Architectural Review Board Staff Report

Project type: Amended Architectural Elevations

Location: 101 Hilltown Village Center

Description: **Hilltown Village Center (AAE):** Amended Architectural Elevations and Architect's Statement of Design for a 13.0 acre tract of land zoned "C-8" Planned Commercial District located at the northeast corner of the intersection of Olive Boulevard and Chesterfield Parkway (18S521108 & 18S630327).

Rooftop Equipment of Building C as seen from Right of Way

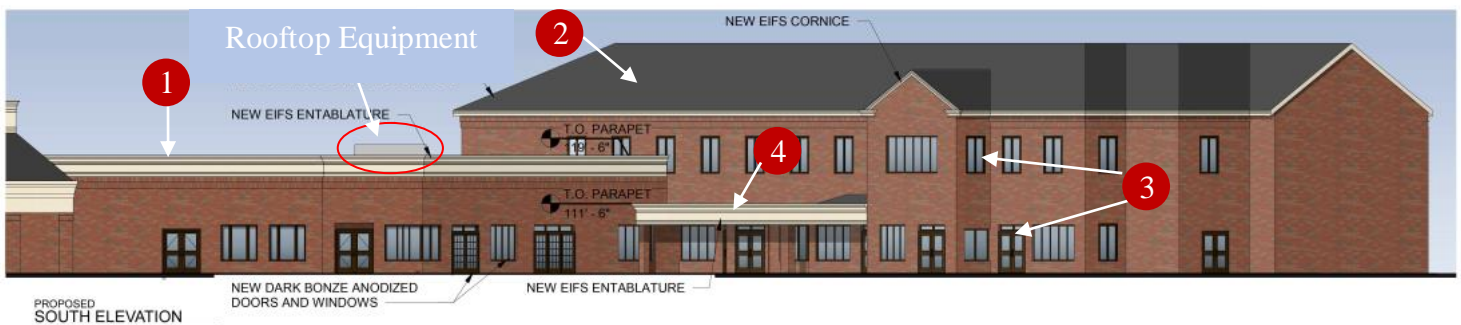
Additionally, the EIFS for building C would add screening of the rooftop equipment to the front facade. It should be noted, however, that as shown in images below, the rooftop equipment can be seen from the rear of the building, including from Hilltown Village Ctr.
